PROPOSED BERRYBANK WIND FARM

AERONAUTICAL IMPACT ASSESSMENT

BERRYBANK WIND FARM

Document Title: Berrybank Wind Farm Aeronautical Impact Assessment

100402-02 Berrybank Wind Farm Obstacle Lighting Design v0.3 151019

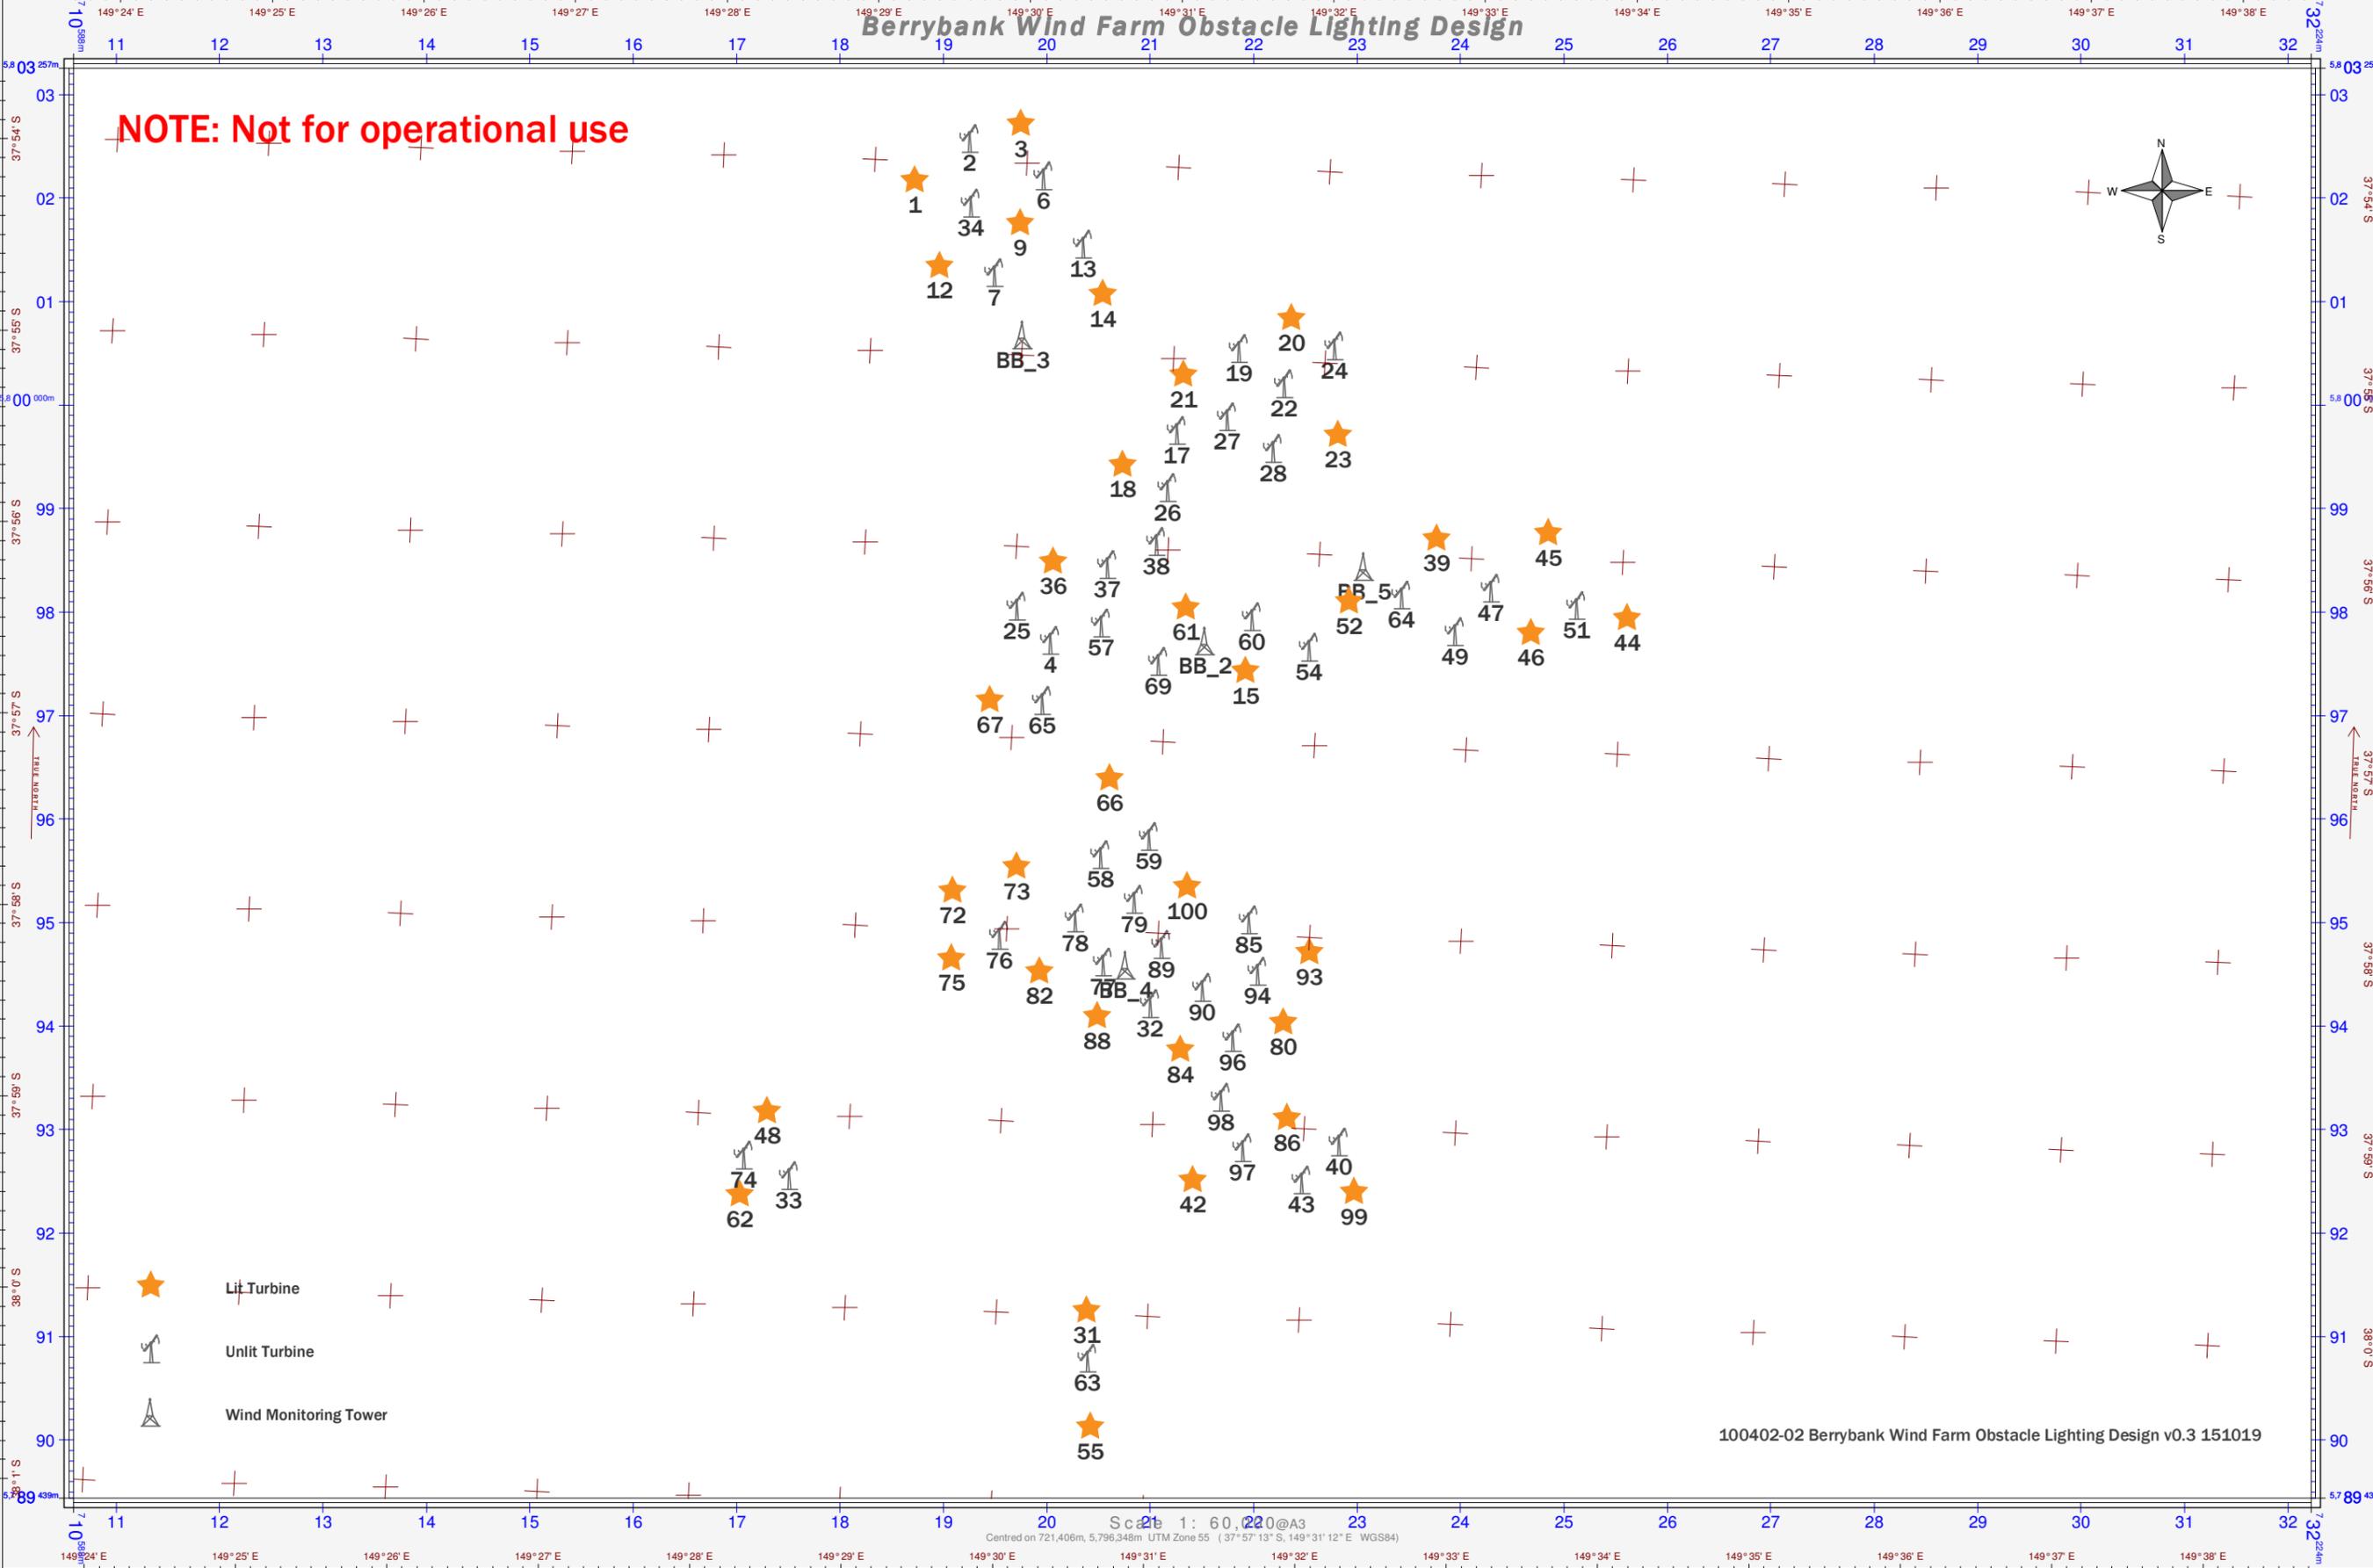
CASA recommends that the wind farm is lit with steady red low intensity lighting at night as per Section 9.4 of the CASA Manual of Standards Part 139. Characteristics for low intensity lights are stated in subsection 9.4.6. CASA agrees that the turbines that should be lit are those identified by the proponent in the drawing '100402-02 Berrybank Wind Farm Obstacle Lighting Design v0.3 151019'.

CASA recommends the wind farm is lit with steady red low intensity lighting at night as per Section 9.4 of the CASA Manual of Standards Part 139. Characteristics for low intensity lights are stated in subsection 9.4.6. CASA agrees that the turbines that should be lit are those identified in the drawing '100402-02 Berrybank Wind Farm Obstacle Lighting Design v0.3 151019'.
